~~ADDENDUM TO THE ADDED DRAINAGE STUDY FOR~~

**WATERPARK SUBDIVISION FILING NO. 1**  
**2430 S. Havana Street**  
**City of Aurora, County of Arapahoe, Colorado**

Green comments provided  
by Public Works reviewer  
Jared Coleman -  
jcoleman@auroragov.org

*Addendum to the Addended Drainage Study for Waterpark Subdivision Filing NO. 1*

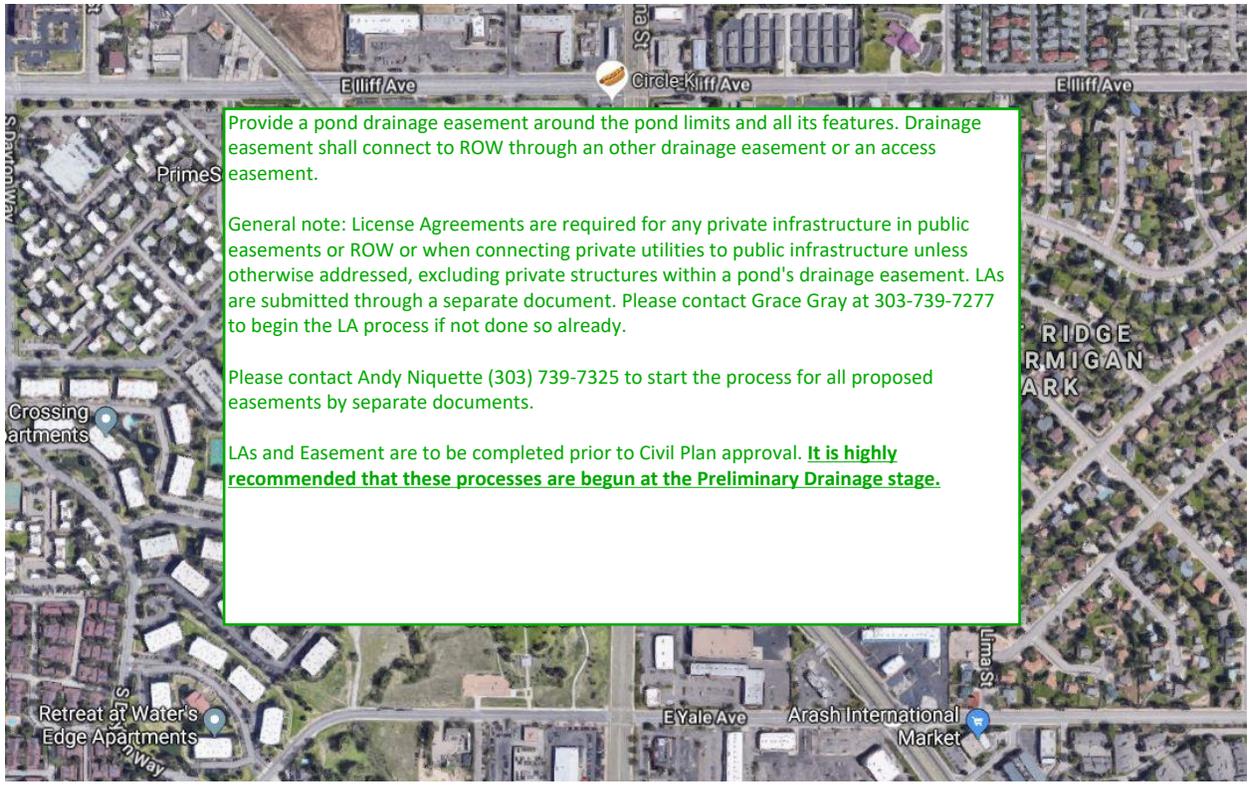
Advisory note:  
This PDR approval  
required prior to Civil  
Plan approval

Provide a pond drainage easement around the pond limits and all its features. Drainage easement shall connect to ROW through an other drainage easement or an access easement.

LAs and Easement are to be completed prior to Civil Plan approval. **It is highly recommended that these processes are begun at the Preliminary Drainage stage.**

Filing 2 per plat (typ)  
**ADDRESSED**

**NOTED**

### Vicinity Map

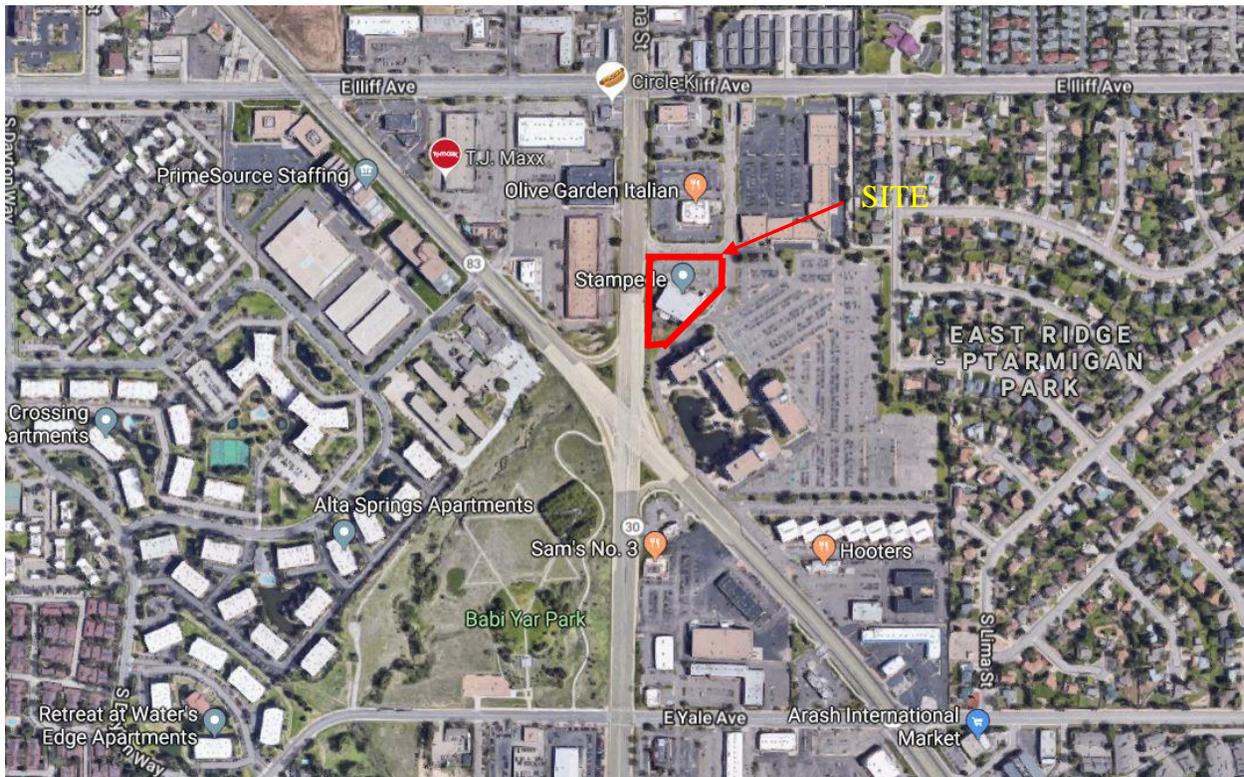
Also include:  
NRCS Soil map with site delineated  
FEMA FIRM with site delineated  
Please make sure to rotate any sheet right side up.

**ADDED**
